Service Bulletin No. 339

MODEL D Series Coaches equipped w/ C13 engine & 50DN alternator	TYPE Field Change Program	SECTION/GROUP 7 – Electrical	DATE Nov. 19, 2009
SUBJECT 50DN ALTERNATOR CABLE CHAFING			
CONDITIONS

Ref. NHTSA Recall No.: 09V–446

Figure 1. Pre-2007 C13 engine configuration.

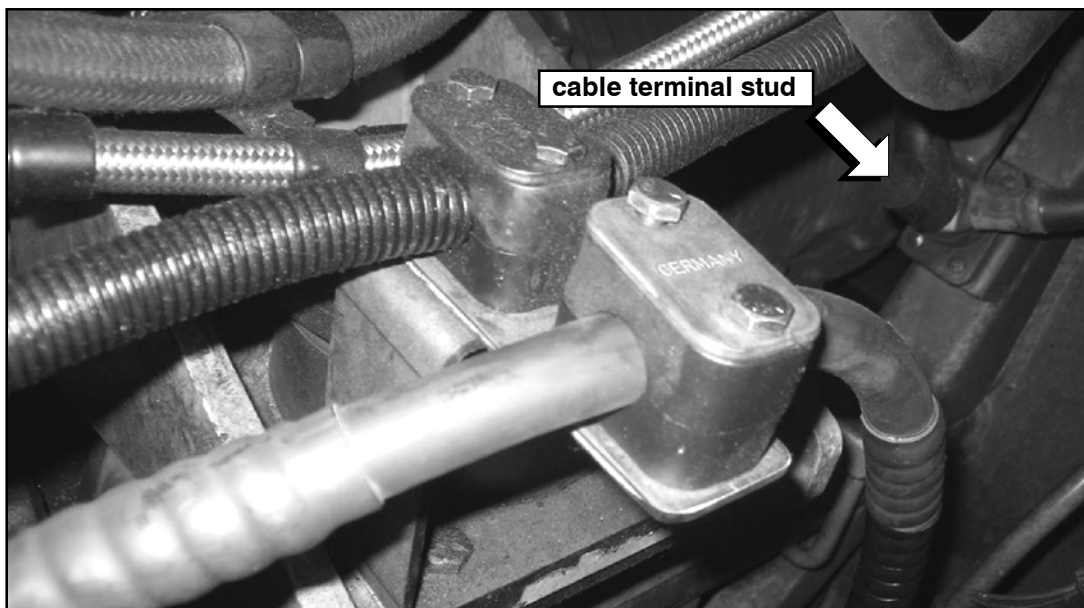
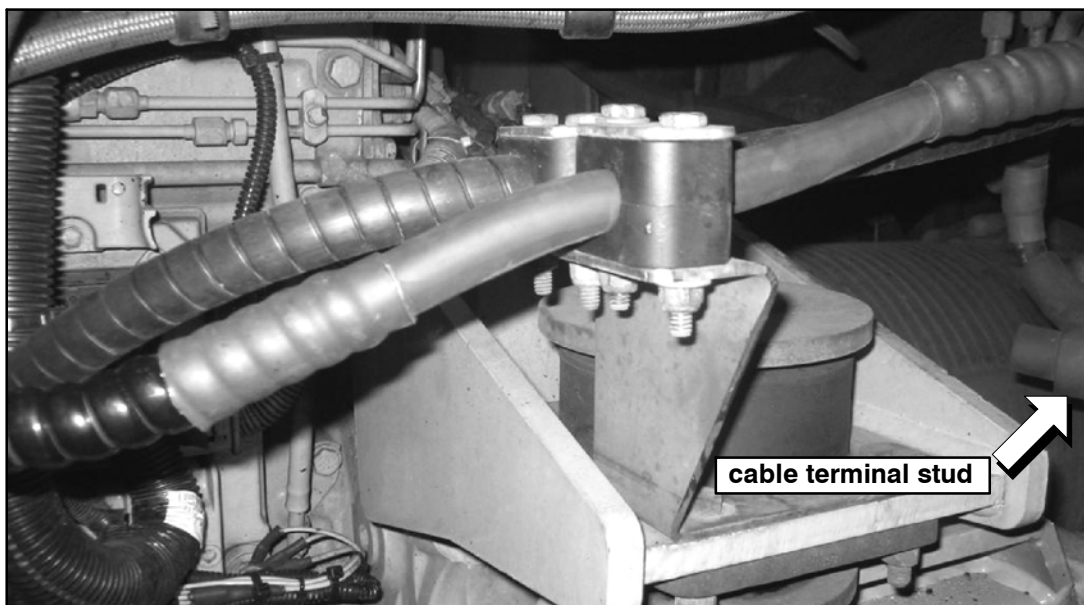
1. Turn the main battery disconnect switch to the OFF position. Chock both sides of the tires.
2. Open the engine compartment and curbside, rear side service compartment doors.
3. Locate the 50DN alternator. Disconnect the alternator cable from the 50DN alternator.
4. Remove and discard the alternator cable support bracket. Retain the mounting bolts.
5. Locate the cable terminal stud on the forward wall of the curbside, rear side service compartment (refer to Figure 1 or Figure 2). Remove and retain the nut. Remove the alternator cable from the cable terminal stud.

Figure 3. Pre-2007 C13 engine configuration.

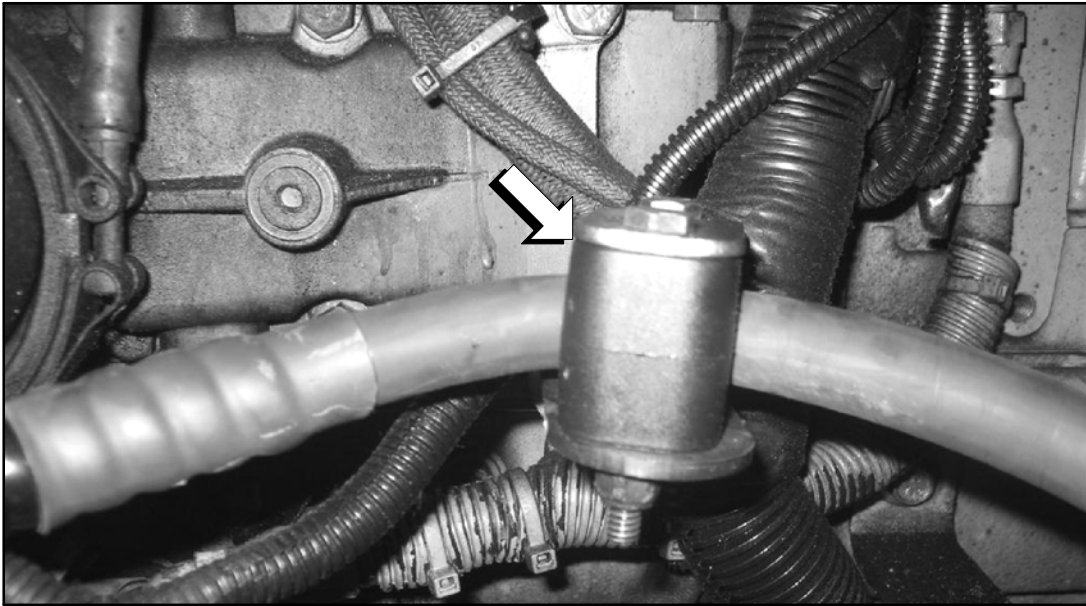
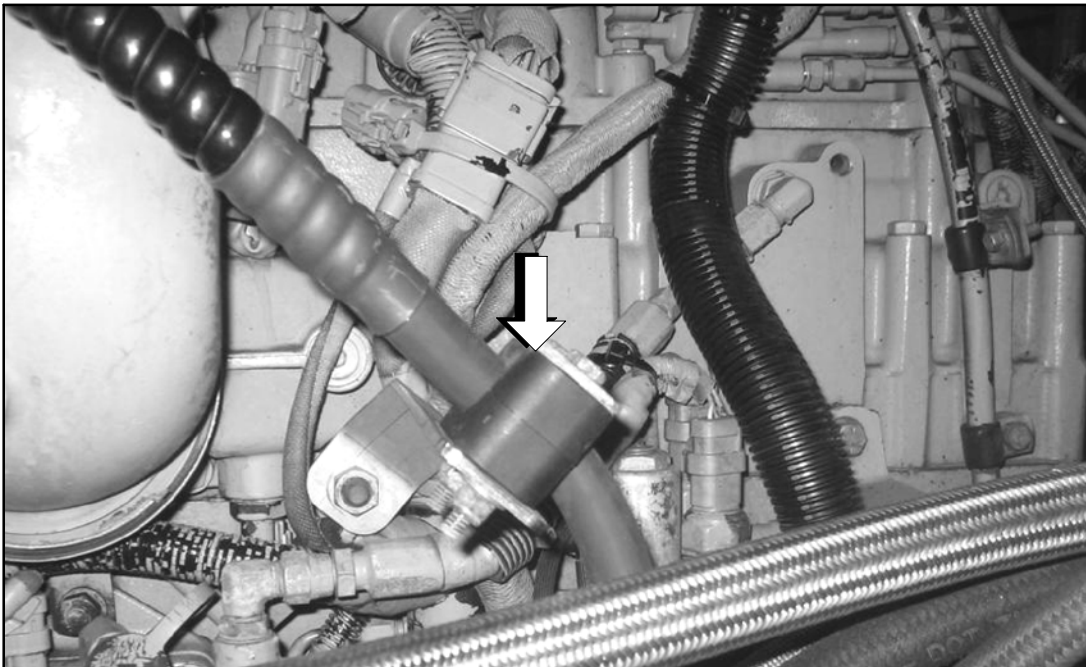
6. Follow the routing of the alternator cable along the curbside of the C13 engine. Release alternator cable from existing split clamps (refer to Figure 3 or Figure 4). Remove and discard the alternator cable.

- Remove the existing split clamps with new split clamp, p/n 19-04-0419 (refer to Figure 3 or Figure 4). Use existing capscrew 19-1-376 and lock nut 19-3-2 to secure alternator cable. Torque to 9 ft. lbs.
- Remove and discard existing P clamp on alternator cable (refer to Figure 6). Use existing hardware, install new P clamp, p/n 19-4-26.

Figure 7. Pre-2007 C13 engine configuration.

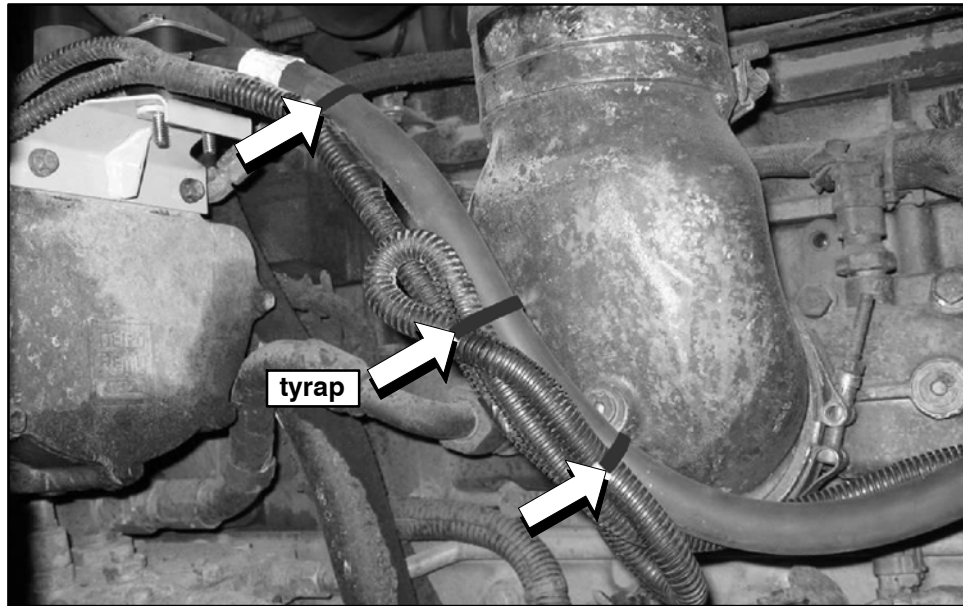
For coaches equipped with the Pre-2007 C13 engine configuration, use tyraps, p/n 19-11-569, to secure existing field wire split loom to the alternator cable (refer to Figure 7).
